**[Docket No. FAA–2021–0189; Project Identifier AD–2020–00645–R; Amendment 39–21875; AD 2021–26–16]**

**Airworthiness Directives; Various Restricted Category Helicopters**

**2021–26–16 Various Restricted Category Helicopters:** Amendment 39–21875; Docket No. FAA–2021–0189; Project Identifier AD–2020–00645–R.

Figure 1 to the Introductory Text of Paragraph (g)(3) – Main Driveshaft Installation and Removal Tool

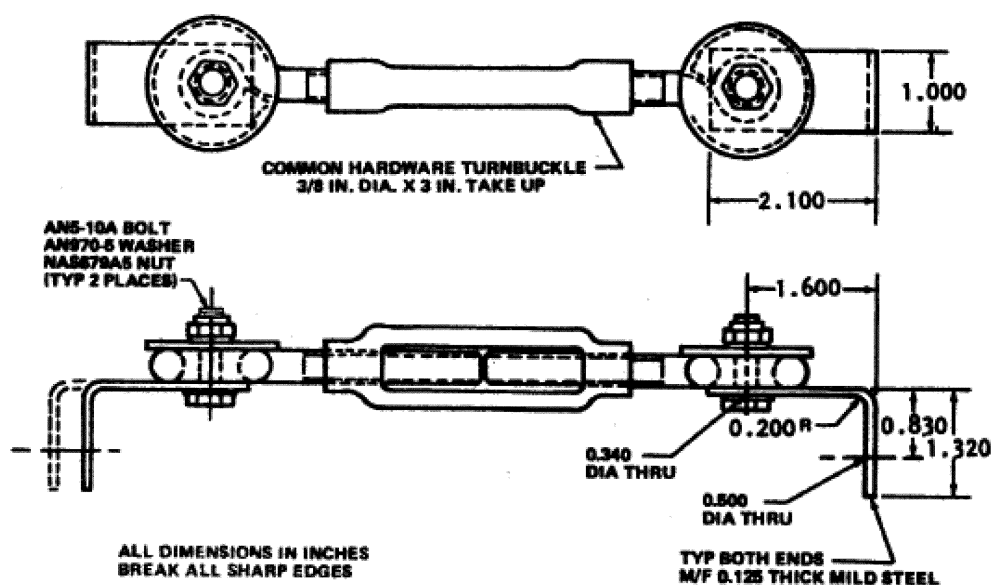
(3) Within 25 hours TIS after the effective date of this AD, remove main driveshaft P/N SKCP2180–1, SKCP2281–1, SKCP2281–1R, or SKCP2281–103 by following “6–24.3. Removal—Main Driveshaft P/N SKCP2281–103” on page 6–24, including “4–24. Removal—Air Inlet Filters” on page 4–17 and “Figure 4–9. Engine Air Inlet Filter Installation” on page 4–16, of Headquarters, Department of the Army, Aviation Unit and Intermediate Maintenance Instructions Army Model UH–1H/V/EH–1H/X Helicopters, Technical Manual TM 55–1520–210–23–1, Change No. 42, dated April 14, 2003 (TM 55–1520–210–23–1 C 42), except where instructed to “refer to figure 6–12.2” in TM 55–1520–210–23–1 C 42, refer to Figure 1 to the introductory text of paragraph (g)(3) of this AD, and where instructed to “see figure 6–12.3” in TM 55–1520–210–23–1 C 42, see Figure 2 to the introductory text of paragraph (g)(3) of this AD, and:

Figure 3 to Paragraph (g)(3)(iv) – Damage Limits

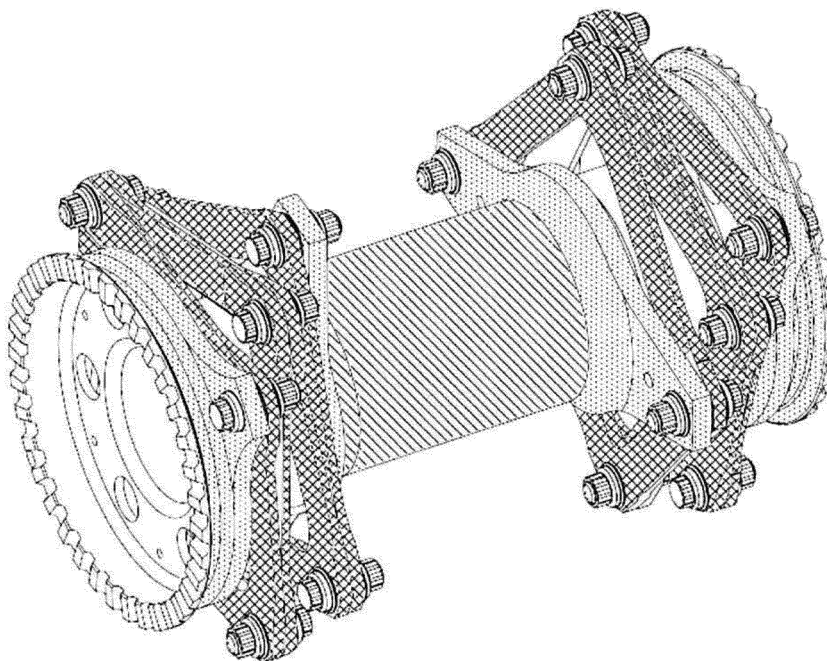
(iv) Inspect the main driveshaft for mechanical damage, corrosion, an edge dent, and nick as shown in Figure 3 to paragraph (g)(3)(iv) of this AD. For the purposes of this inspection, mechanical damage may be indicated by a crack, scratch, or wear; and corrosion may be indicated by corrosion or pitting. If there is a scratch, wear, corrosion, pitting, an edge dent, or a nick within allowable limits, before further flight, repair the main driveshaft in accordance with FAA-approved procedures. If there is a crack, or a scratch, wear, corrosion, pitting, an edge dent, or a nick that exceeds allowable limits,

before further flight, replace the main driveshaft. The main drive shaft may be overhauled in accordance with FAA-

approved procedures to accomplish the replacement required by this paragraph.
